**PRELIMINARY DRAINAGE REPORT  
FOR  
STERLING RANCH PHASE 2 PRELIMINARY PLAN**

**Engineering Review**

**October 1, 2020  
Project No. 25188.02  
SP-20-003**

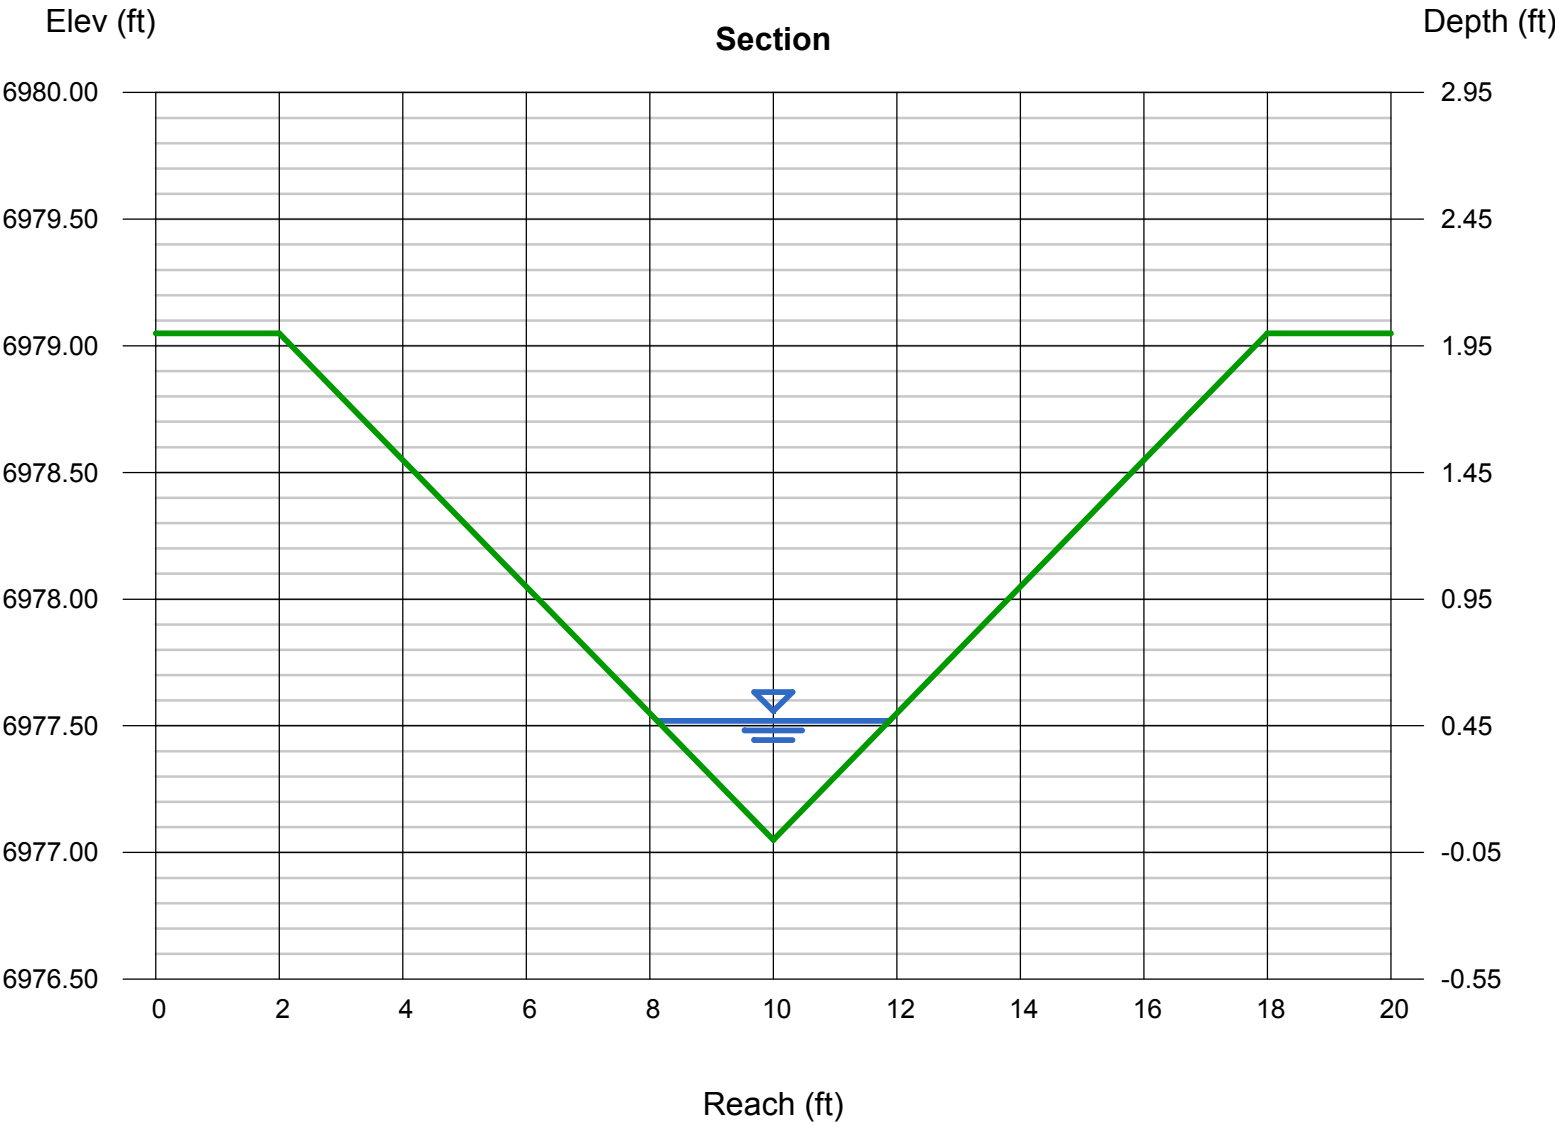
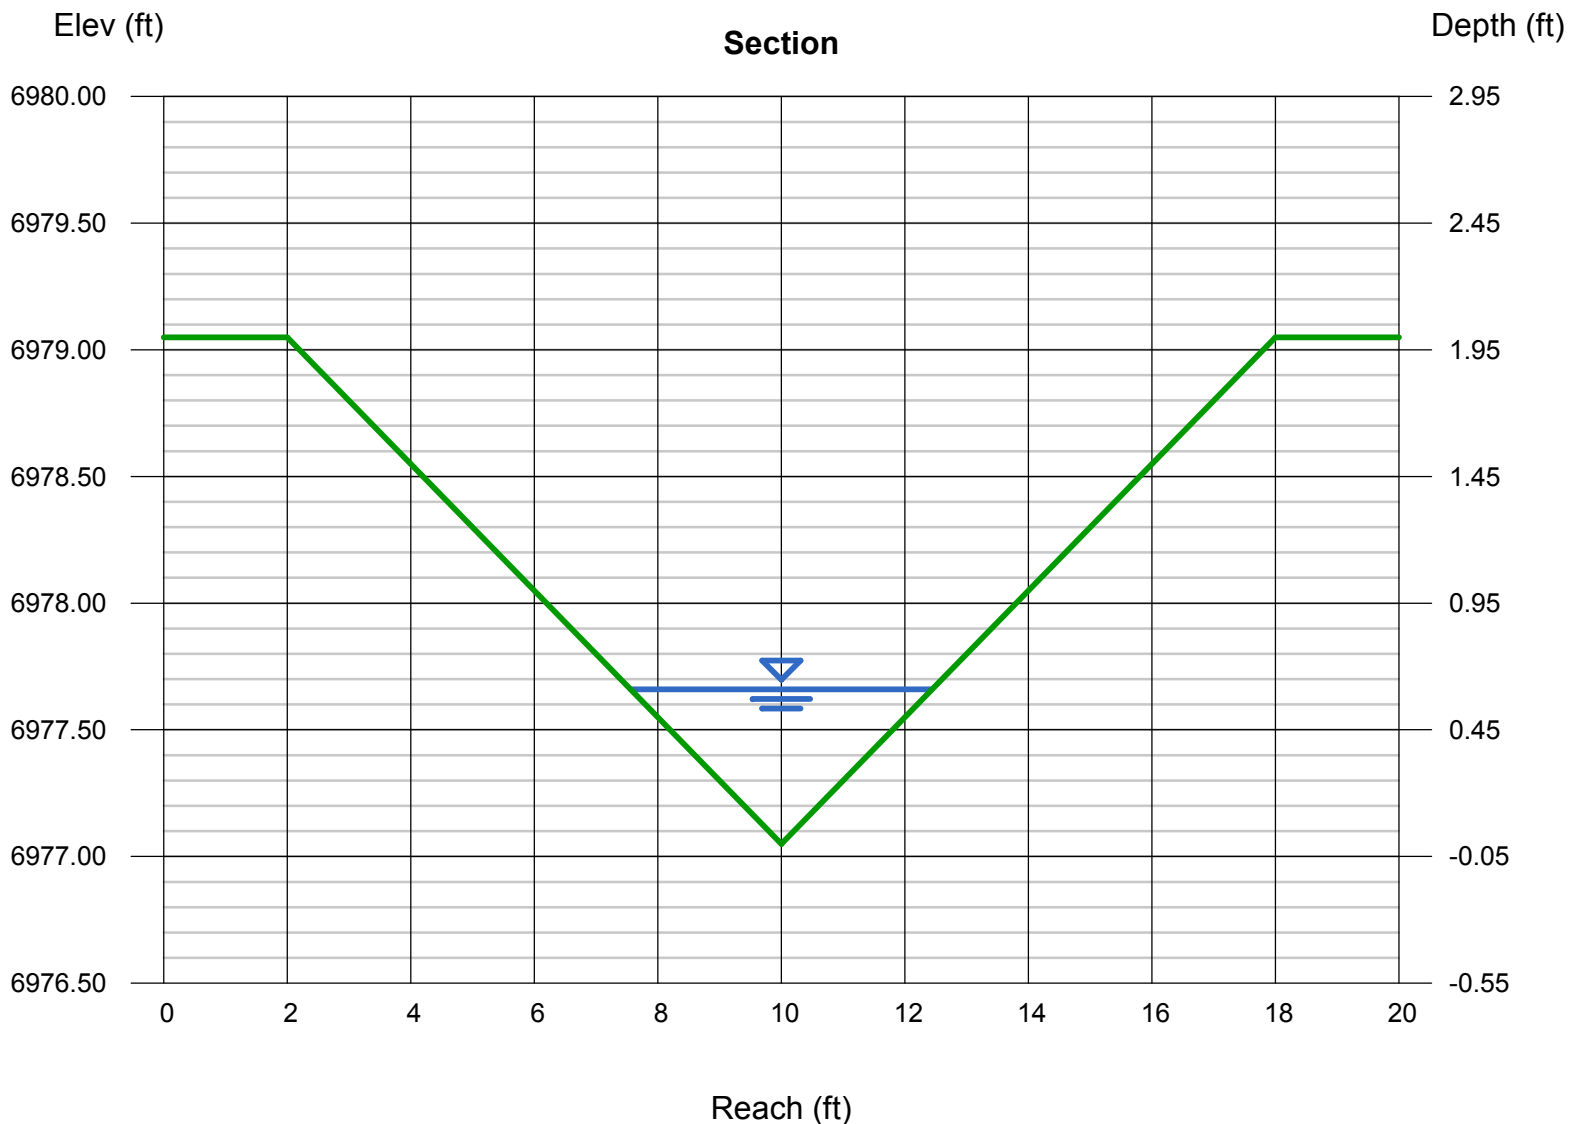
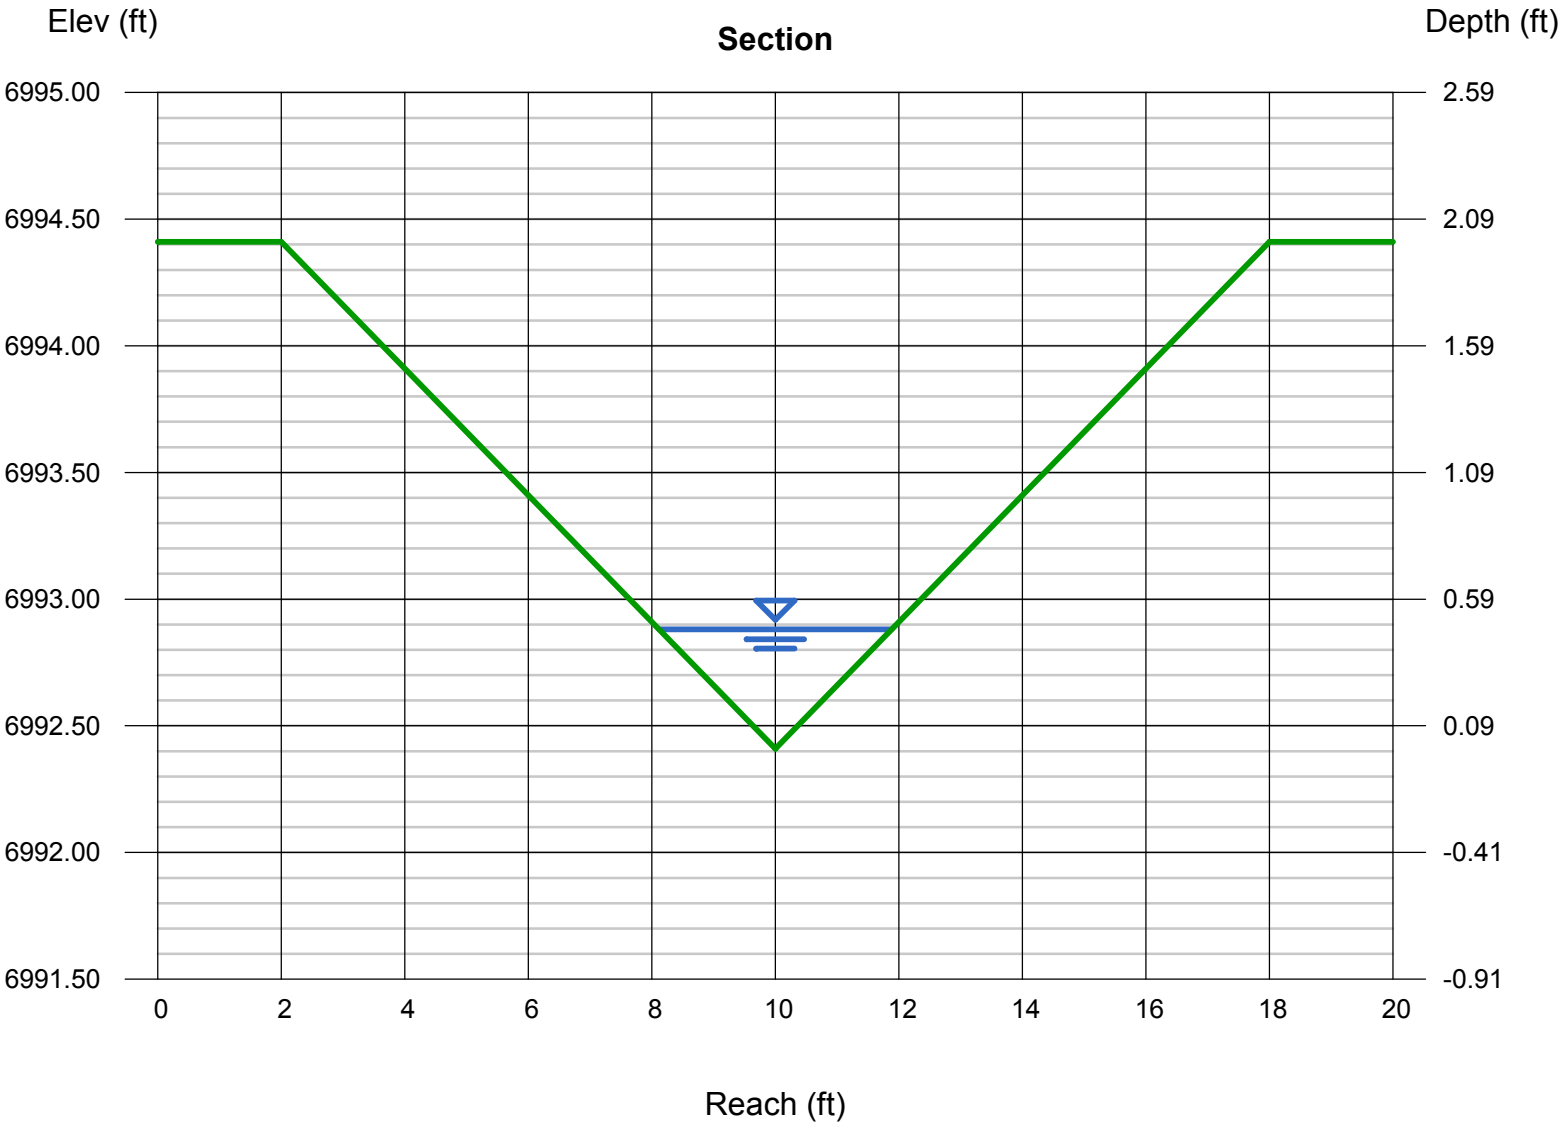
inlet?

Provide inlet, culvert and pipe calculations.

JR Response: inlet  
calculations provided.  
Pipe calculations w/ hgl  
provided for interm area

STERLING RANCH PHASE 2  
EXISTING DRAINAGE MAP  
JOB NO. 25188.02  
10/01/20  
SHEET 1 OF 1

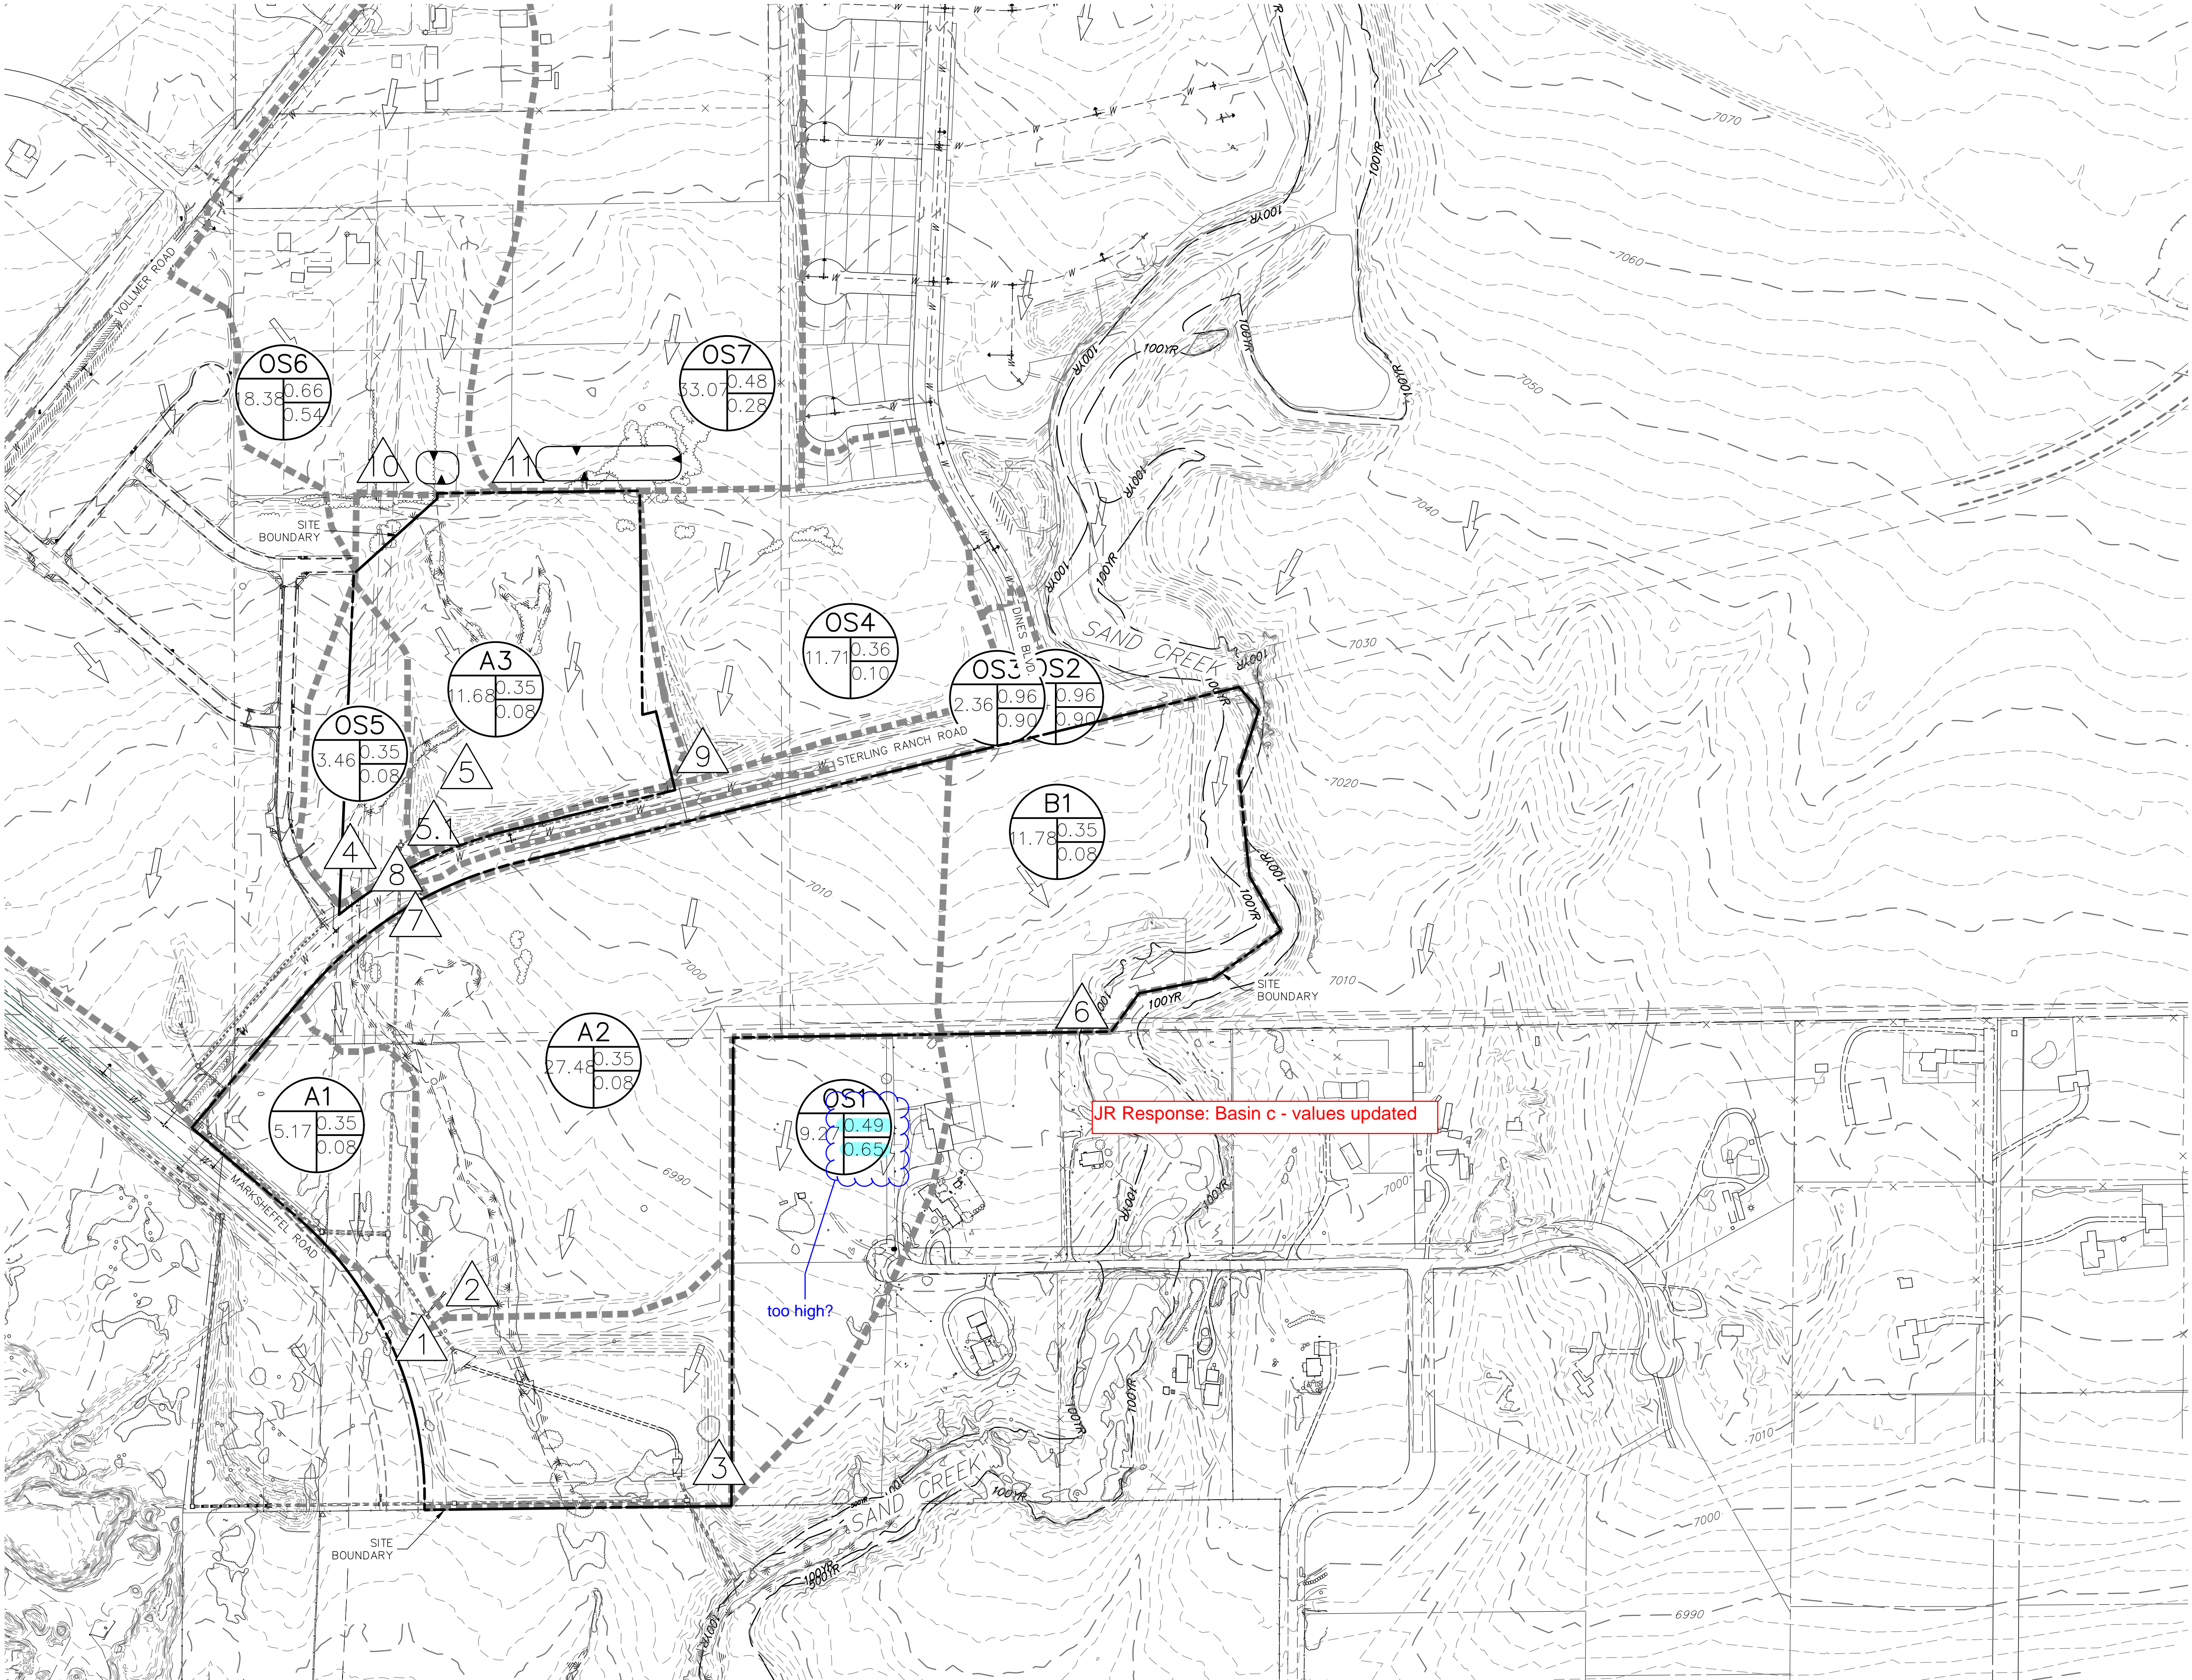
Also provide DP summary

JR Response: DP summary table added

JR Response: Basin c - values updated
